PLANNING NMA-CHANGE LIST		
ID	Proposed Changes to plans that are 'Non Material'	Reason for 'Amendment'
A	Changes to Common stair towards compliance for general access where a clear landing needs to be provided and to accommodate smoke control. Circulation area and internal doorway to stairs rearranged to adapt corridor aisle. Stairs, structurally stacked for construction leading towards the corridor or lobby next to the stair being provided with a smoke vent and a store area provision on ground level. Rearrangement in plan due to the above visible on the Northeast facade. Window openings, adapted to suit mentioned changes/rearrangement.	Compliance towards Building Regulations, Part-K-Protection from falling, collision and impact and Part-B-Fire safety
B	Changes to Communal lifts and stairs towards compliance for firefighting where a firefighting shaft is required as the building is over 18m and to accommodate smoke control and building services. Circulation area internal doorway to stairs and clear landing for lifts rearranged to adapt corridor aisle. Stairs, structurally stacked for construction leading towards a vertical smoke shaft that opens at roof level with rationalised comm

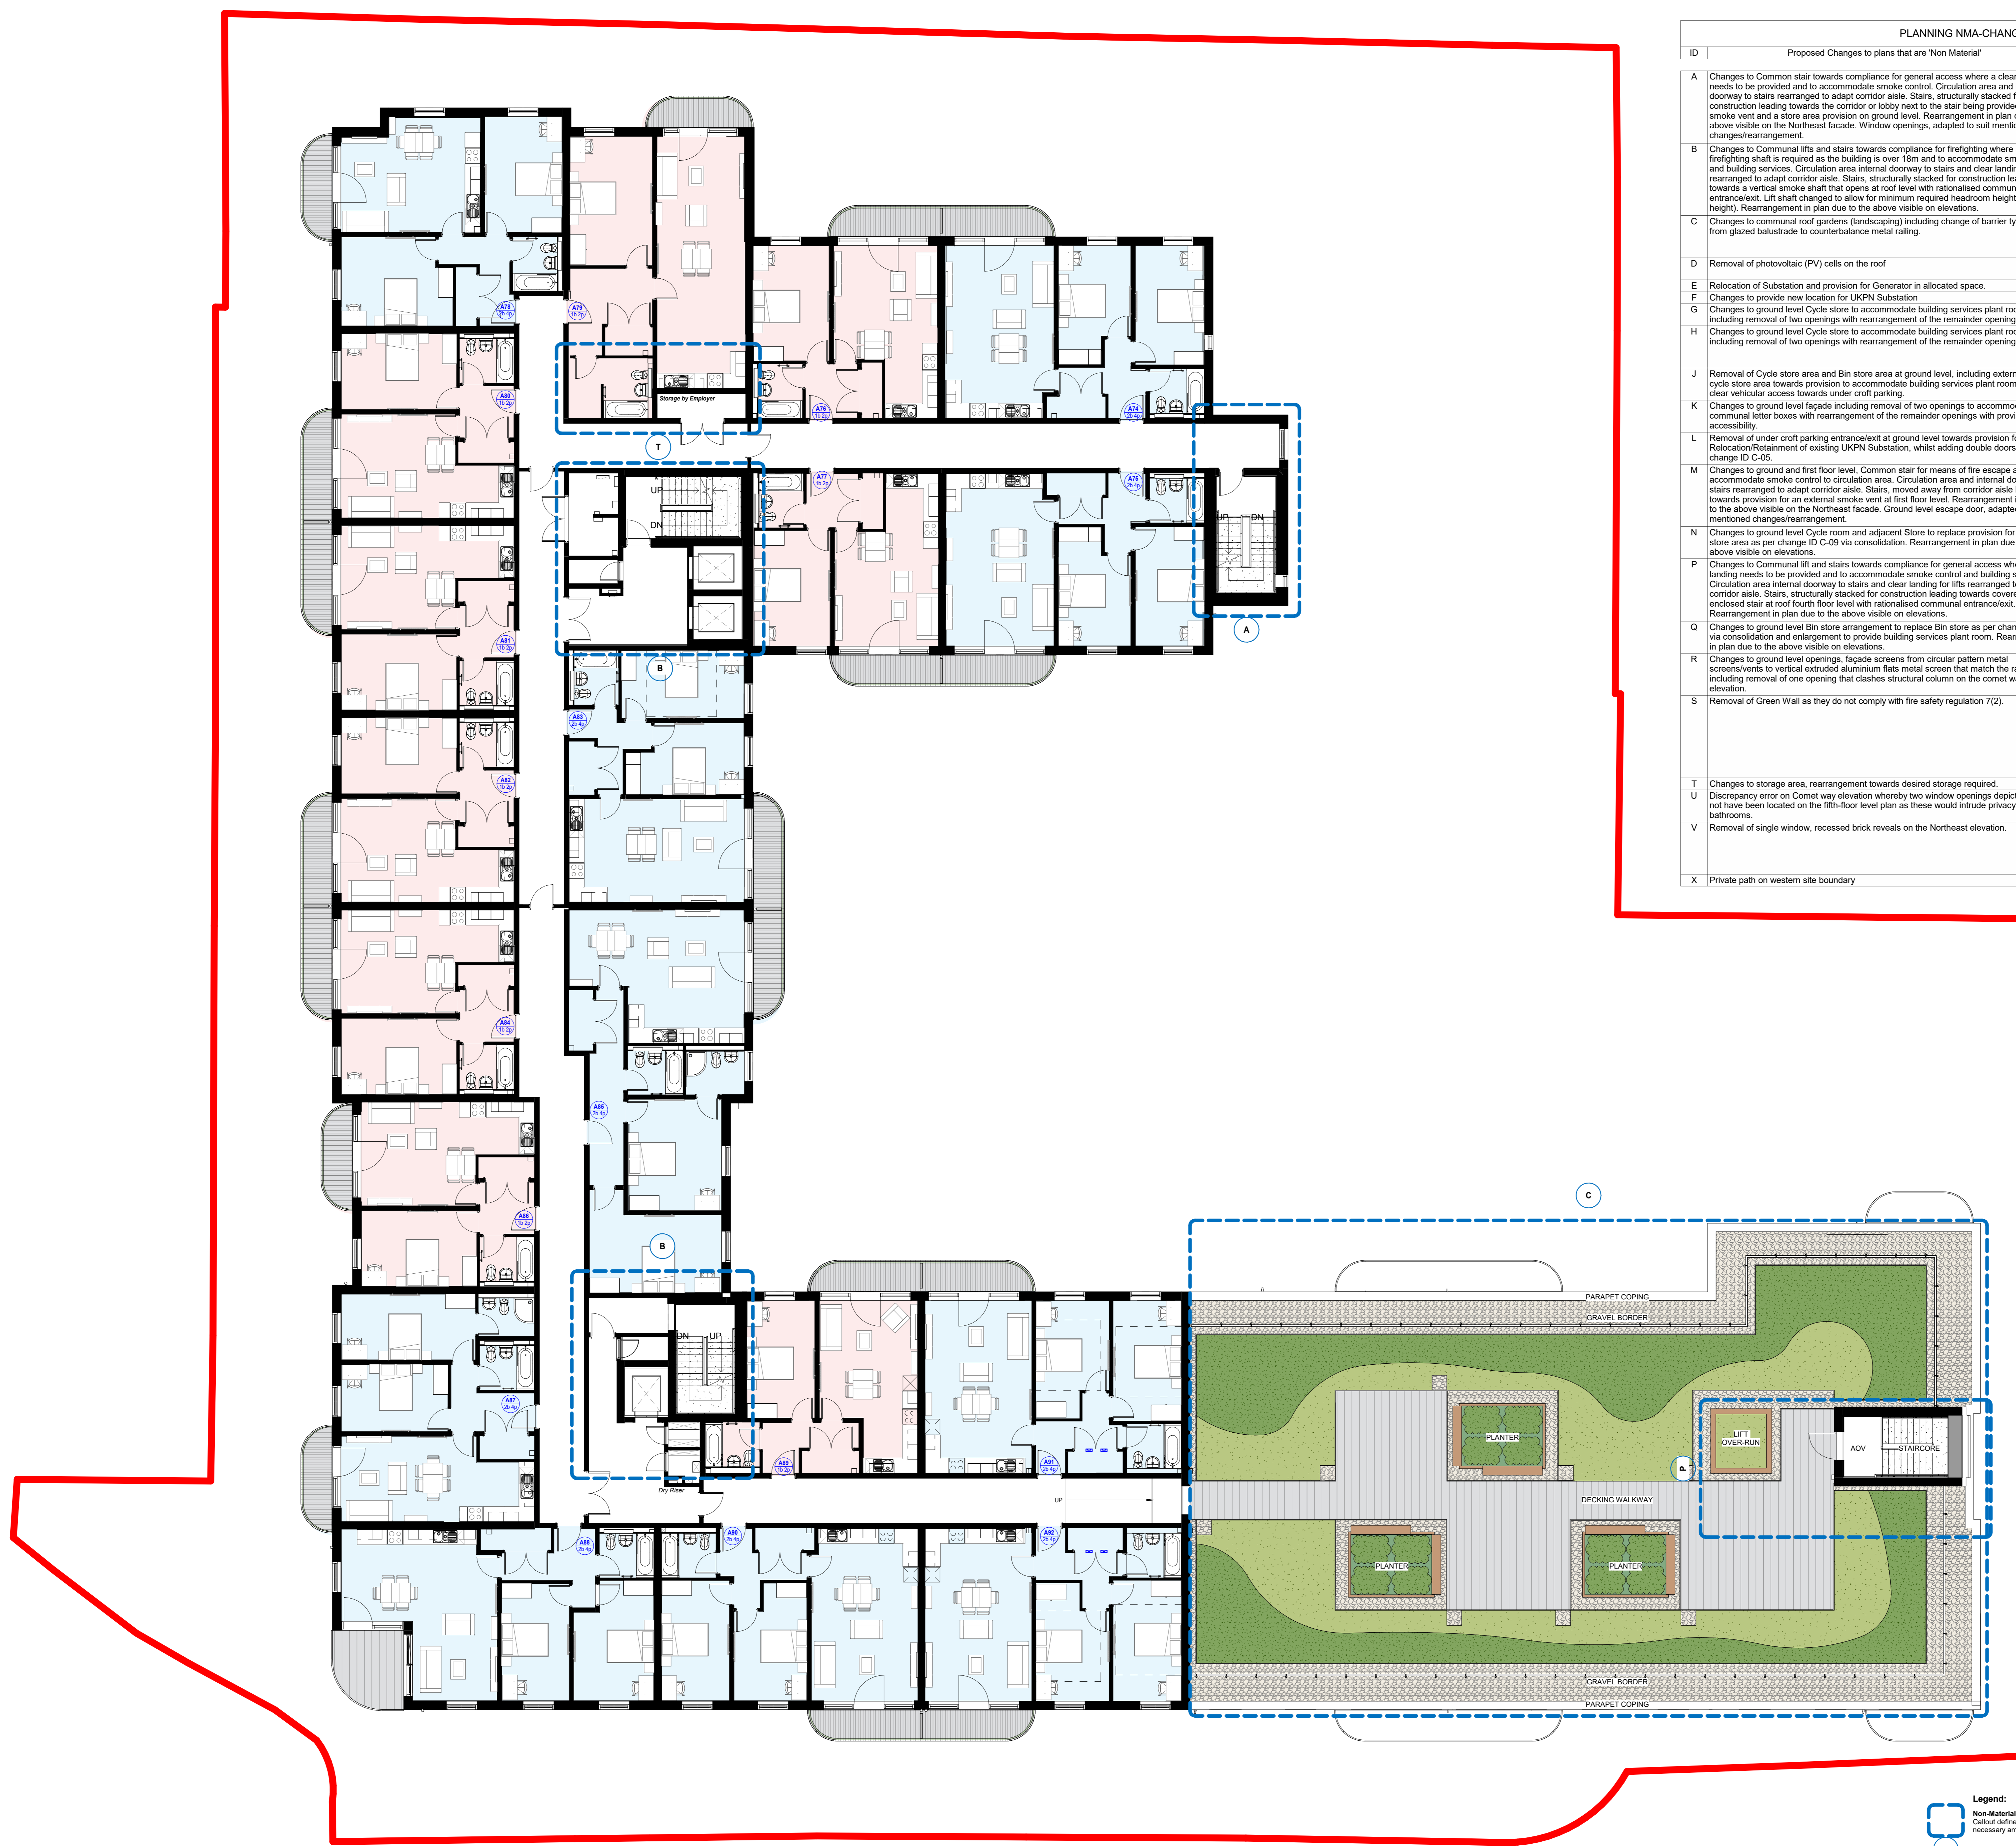
C	Changes to communal roof gardens (landscaping) including change of barrier type (railing) from glazed balustrade to counterbalance metal railing.	To contribute positively towards biodiversity via balance of soft and hard landscaping schemes including provisions for bird and bat boxes, whilst maintaining overall uniformity for railing type
D	Removal of photovoltaic (PV) cells on the roof	PV was not required as Part L requirement was met using Exhaust Air Heat Pumps
E	Relocation of Substation and provision for Generator in allocated space.	Provision for separate secluded area for generator
F	Changes to provide new location for UKPN Substation	Provision for future relocation for UKPN Substation
G	Changes to ground level Cycle store to accommodate building services plant rooms including removal of two openings with rearrangement of the remainder openings.	Provision towards Building Services, Secondary LV switch room and Comms room.

H	Changes to ground level Cycle store to accommodate building services plant rooms including removal of two openings with rearrangement of the remainder openings.	Provision towards secure access and splitting into 4 small bin stores to comply with recent updates of having maximum 8 large (1100lrs) receptacles within.
J	Removal of Cycle store area and Bin store area at ground level, including external door in cycle store area towards provision to accommodate building services plant room including clear vehicular access towards undercroft parking.	Provision towards Building Services, Primary LV switch room and vehicular access towards undercroft parking.
K	Changes to ground level facade including removal of two openings to accommodate communal letter boxes with rearrangement of the remainder openings with provision for accessibility.	Provision towards communal letter boxes
L	Removal of undercroft parking entrance/exit at ground level towards provision for Relocation/Retainment of existing UKPN Substation, whilst adding double doors as per change ID C-05.	Provision towards single point of entry/exit for undercroft parking and towards relocation/retainment of existing UKPN Substation mentioned in change ID-E.

M	Changes to ground and first floor level, Common stair for means of fire escape and to accommodate smoke control to circulation area. Circulation area and internal doorway to stairs rearranged to adapt corridor aisle. Stairs, moved away from corridor aisle leading towards provision for an external smoke vent at first floor level. Rearrangement in plan due to the above visible on the Northeast facade. Ground level escape door, adapted to suit mentioned changes/rearrangement.	Compliance towards Building Regulations, Part-B-Fire safety.
N	Changes to ground level Cycle room and adjacent Store to replace provision for Cycle store area as per change ID C-09 via consolidation. Rearrangement in plan due to the above visible on elevations.	Provision towards replacement of removed cycle store mentioned in change ID-J.
P	Changes to Communal lift and stairs towards compliance for general access where a clear landing needs to be provided and to accommodate smoke control and building services. Circulation area internal doorway to stairs and clear landing for lifts rearranged to adapt corridor aisle. Stairs, structurally stacked for construction leading towards covered and enclosed stair at roof fourth floor level with rationalised communal entrance/exit. Rearrangement in plan due to the above visible on elevations.	Compliance towards Building Regulations, Part-K-Protection from falling, collision and impact, Part-B-Fire safety and Provision for stair enclosed/walkway that is directly covered.

Q	Changes to ground level Bin store arrangement to replace Bin store as per change ID C-09 via consolidation and enlargement to provide building services plant room. Rearrangement in plan due to the above visible on elevations.	Provision towards replacement of removed Bin store mentioned in change ID-J and provision for BCW Tank room
R	Changes to ground level openings, facade screens from circular pattern metal screens/vents to vertical extruded aluminium flats metal screen that match the railing type, including removal of one opening that clashes structural column on the corner way elevation.	To maintaining overall architectural uniformity and structural framing.
S	Removal of Green Wall as they do not comply with fire safety regulation 7(2).	Regulation 7(2), requires all residential blocks with top-storey heights over 18m to have all materials which become part of an external wall or specified attachment (e.g., balconies) to achieve class A2-s1, d0 or class A1, except for materials which are exempt as per regulation 7(3). Additionally, membranes used as part of external wall construction above ground should achieve a minimum of class B-s3, d0.

T	Changes to storage area, rearrangement towards desired storage required.	Provision towards desired storage required.
U	Discrepancy error on Comet way elevation whereby two window openings depicted would not have been located on the fifth-floor level plan as these would intrude privacy for the bathrooms.	Discrepancy error
V	Removal of single window, recessed brick reveals on the Northeast elevation.	The recessed brick reveals is towards the left of a single pane window for levels 1-4, whilst it changes to a double pane for level 5. To maintain architectural uniformity, we have detailed a constant double pane window for all levels.
X	Private path on western site boundary	For Façade maintenance MEWP access.
